APP/16/00921 - Dolphin Quay, Queen Street, Emsworth

Further to my letter dated 17/04/19, I write concerning the revised existing and proposed site levels the applicant has submitted in regard to Condition 3.

JIM GARLAND ARCHITECTS LTD ONE DOLPHIN QUAY EMSWORTH PO10 7BU 01243 370502 01243 378127 email: info@garland.org.uk			
Client -					
Job Title Dolphin Quay Boatyard					
Drawing Title Approved Section AA with levels					
Scale	Date	Drawn	Checked		
1:150	17/04/19	JAG	-		
Drawing Number	Revision	Drawn By		Drawn Date	
1405/2000	P1				
				A3

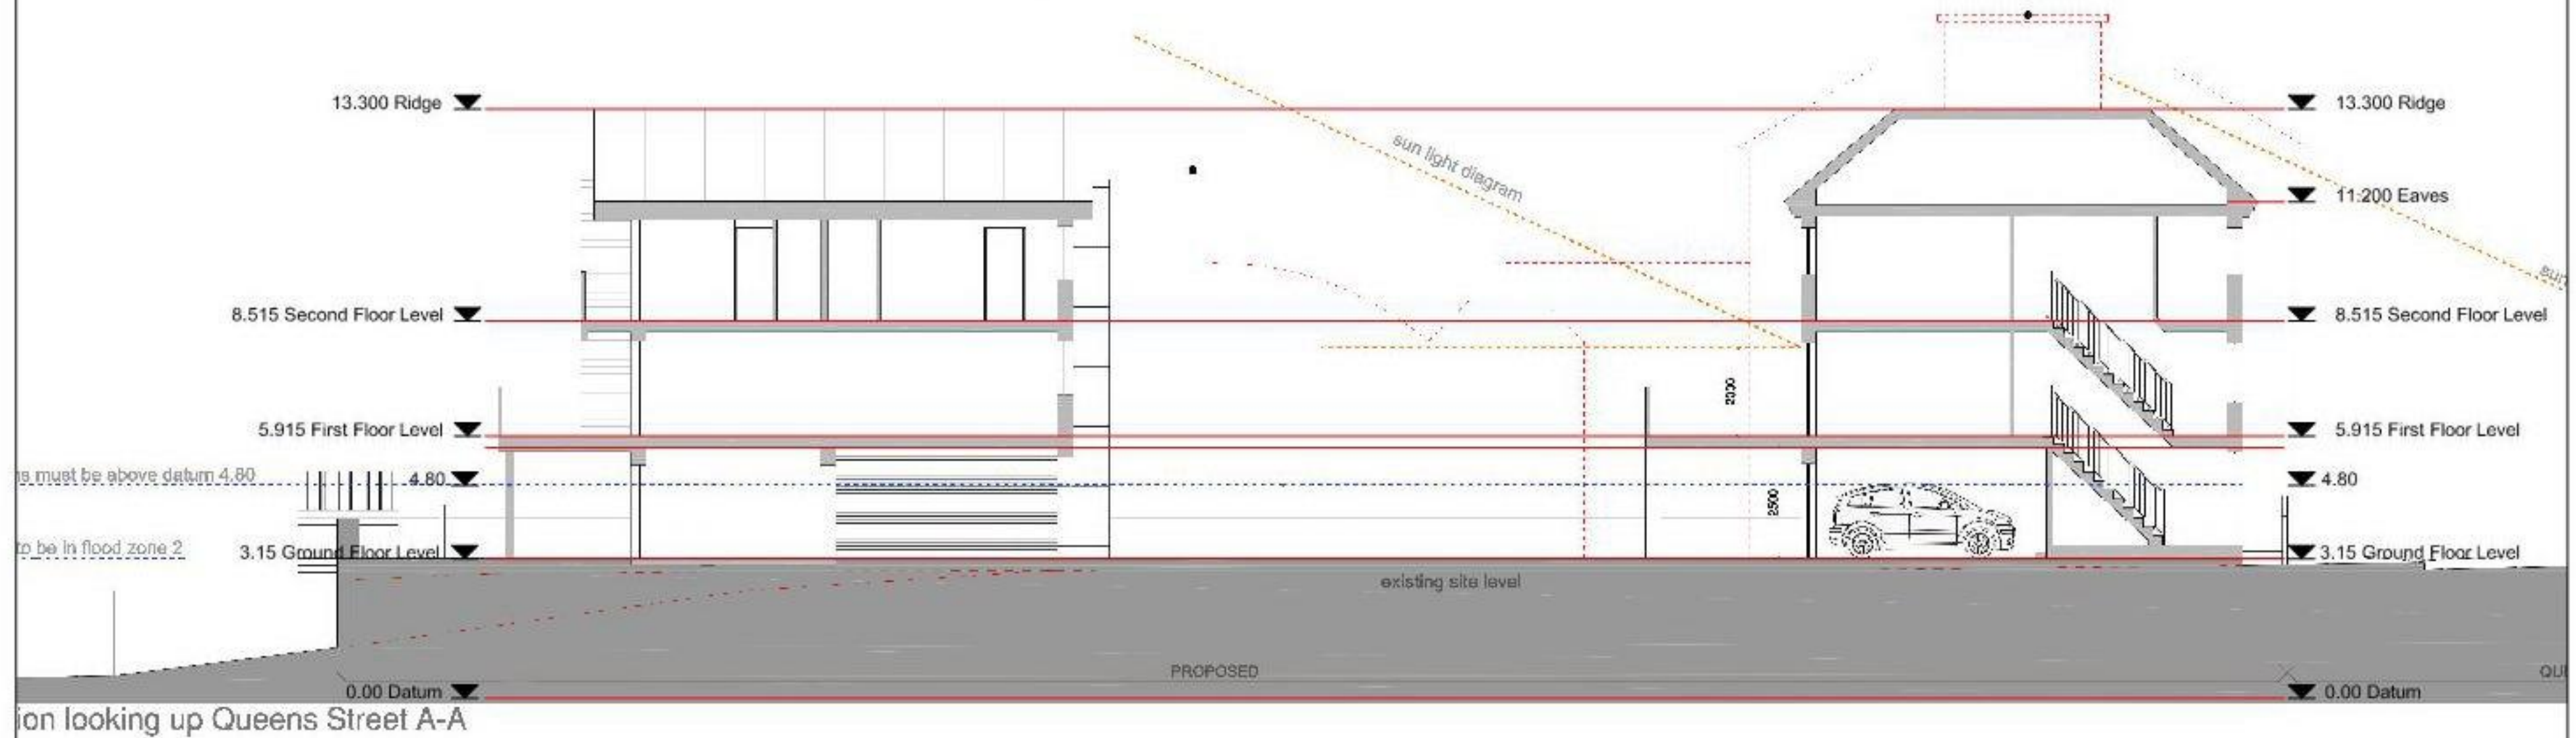
I note that the drawing 27958-PD130/A, published online 24/04/19, is exactly the same drawing as that published online 16/04/19, with no changes to the proposed levels stated therein.

My comments regarding the discrepancy between the approved drawings and those now submitted therefore remain unchanged.

1. No levels have been given for the proposed second floor of the development. The condition does not restrict itself to merely the ground and first floor levels.
2. In the absence of dimensioned drawings from the applicant, I have imported the approved drawing 109B (proposed site section A-A) into AutoCAD to check the approved levels against those now being proposed. My findings are that the approved drawing 109B shows the first floor levels to be the same for all units, at a FFL of 5.915 (please see attached drawing 1405/2000/PI). The drawings submitted for discharge of condition 3 state a FFL of 5.975 (plots 1 & 2) and 6.095 (plots 3-6). This represents an increase of 60mm for plots 1 & 2, and 180mm for plots 3-4.

As these levels do not accord with the approved drawings (Condition 2), I assume that the Council will not be discharging this condition until the levels are corrected.

3. For the record, the FFL for the 2nd floor shown on the approved application drawing is the same for Plots 1 & 2 as it is for Plots 3-6, and as approved has a datum of 8.515. I have taken the opportunity to also establish the eaves and ridge heights shown on the approved drawing, and trust that the Council will ensure that the applicant builds to the approved levels.

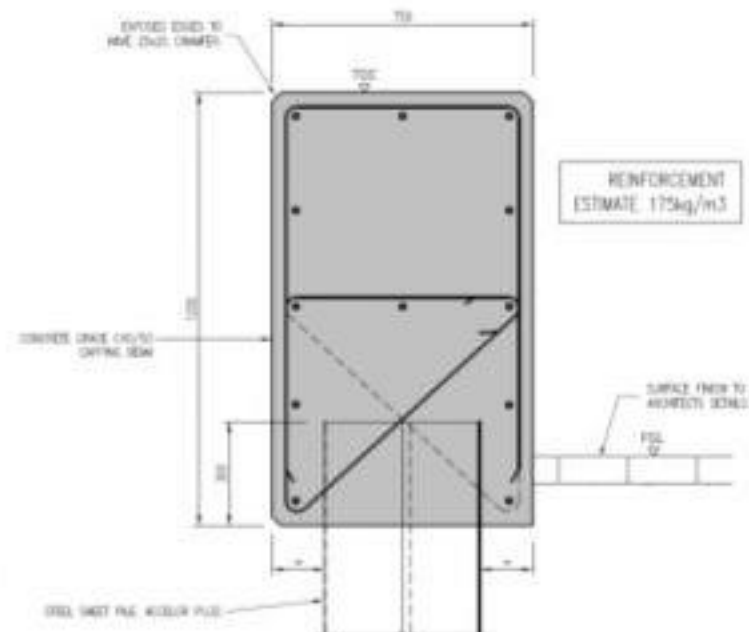
Approved drawing PD108F - Proposed street scene and section plan, shows the new sea wall above the quay being faced either side in brickwork. See extracts below:

However, the drawings submitted by the applicant to the Marine Management Organisation under the Marine and Coastal Access Act 2004 depart from the approved planning drawings by showing the sea wall in a solid reinforced concrete construction, as per the extract from drawing 18-3130-125 Revision P1.

This departure from the approved drawings would have a significant impact on the appearance of the development from both Dolphin Creek and Slipper Millpond.

The brickwork to the replacement quay forms a significant visual element in the photomontage of the Slipper Mill pond view included in the applicants Design & Access Statement (see right). This view will look quite different if constructed with a horizontal concrete band above a timber clad quay wall.
